APPLICATION NO.	FILING DATE	FIRST NAMED INVENTOR	ATTORNEY DOCKET NO.	CONFIRMATION NO.
10/782,982	02/20/2004	Rafail Zubok	532/5	7133
530 LERNER, DAV	7590 09/24/2007 VID, LITTENBERG,		EXAMINER	
KRUMHOLZ & MENTLIK			MILLER, C	HERYL L
600 SOUTH AVENUE WEST WESTFIELD, NJ 07090			ART UNIT	PAPER NUMBER
			3738	
			<u></u>	
			MAIL DATE	DELIVERY MODE
			09/24/2007	PAPER

#### **DETAILED ACTION**

BRUCË SNOW PRIMARY EXAMINER Thachment #1 (marked up

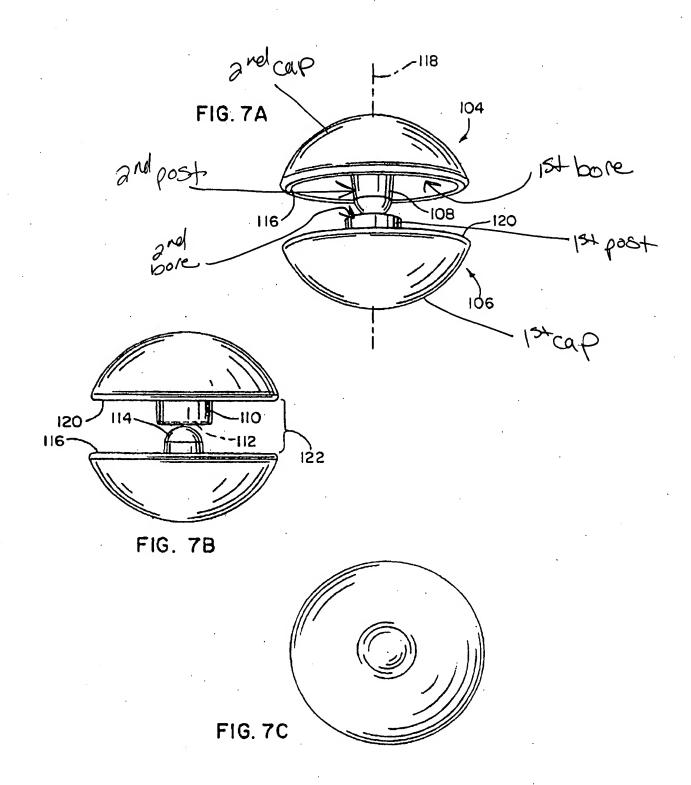
Claims 1-3, 5, 6, 8-10, 12, and 13 are rejected under 35 U.S.C. 102(e) as being anticipated by Songer et al. (US 7,001,433 B2, cited previously). See figures 6a-6e, 7a-7b and col.9 line 17-col.10 line 25. Songer discloses an artificial intervertebral disc comprising a first baseplate (82) with aperture (88), a second baseplate (84) with aperture (90), a bearing mechanism (76; details seen in fig.7a, 7b) coupled to the baseplates (82, 84), comprising a semispherical bearing (outer surface of 76), pair of retaining caps (peaks and valleys of 104 and 106) connected by locking posts (108, 110); said bearing (76) including a first bore (concavity of 104) having a first diameter and a second bore (112) having a second smaller diameter, the bores

aligned; the pair of caps including a first cap (106) having a first post (110) inserted into first bore (concavity of 104), and a second cap (104) inserted into second smaller bore (112) wherein the baseplates rotate relative the bearing mechanism, and wherein the rotation of the baseplates (82, 84) relative the bearing (76) extends the bearing mechanism through the baseplate aperture (at 78 and 80; see fig.6a; the bearing mechanism is partially extending through the aperture during rotation). Songer discloses the baseplates (82, 84) to be outwardly domed (see surfaces 82a and 84a in fig.6B, 6e, and 6f domed is clearly shown). Songer discloses the bearing surfaces of the baseplates to be semispherical (shown as so in fig.6E). See attachment 1.

Attachment #2 (marked up)

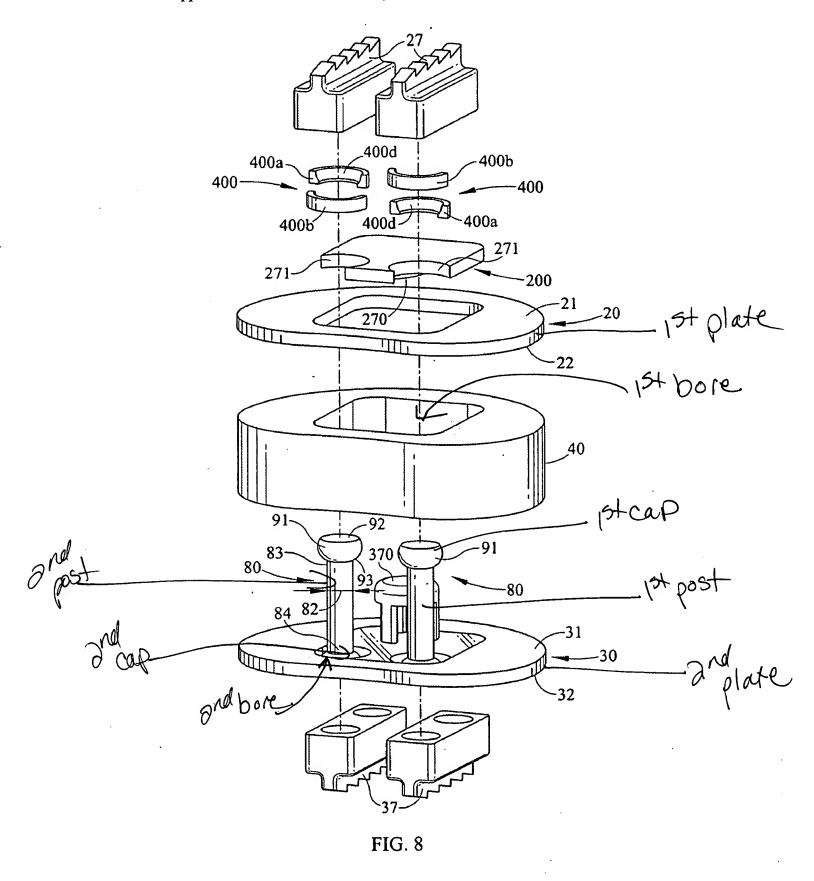
Claims 1-5 are rejected under 35 U.S.C. 102(e) as being anticipated by Navarro et al. (US 2006/0259149 A1). Navarro discloses an artificial intervertebral disc (fig.15) comprising a first baseplate (200 or 20+200) with aperture (271), a second baseplate (300; or 30+300) with aperture (371), a bearing mechanism (motion limiting members) coupled to the baseplates, comprising a semispherical bearing (ball 91), pair of retaining caps (tops 92) connected by locking posts (80), said bearing including a first bore (opening in cushion 40) having a first diameter and a second bore (271 or bore of 400) having a second smaller diameter, the bores aligned; the pair of caps including a first cap (one top 92 seen in fig.8) having a first post (80) inserted into first bore (opening of 40), and a second cap (bottom 92 of another post) inserted into second smaller bore (opening of 400), wherein the baseplates rotate relative the bearing mechanism (some rotation is allowed, although minimal; P0019; fig.2; P0065), and wherein the rotation of the baseplates relative the bearing extends the bearing mechanism through the baseplate aperture (see figs.9, 16, 18). Navarro discloses the bearing surfaces (272, 372) of the

baseplates to be semispherical (fig.9). Navarro discloses the apertures (271, 371) of the baseplates (200, 300) to be tapered (P0069) such that an outwardly facing surface has a larger diameter (see fig.9). See attachment 2.
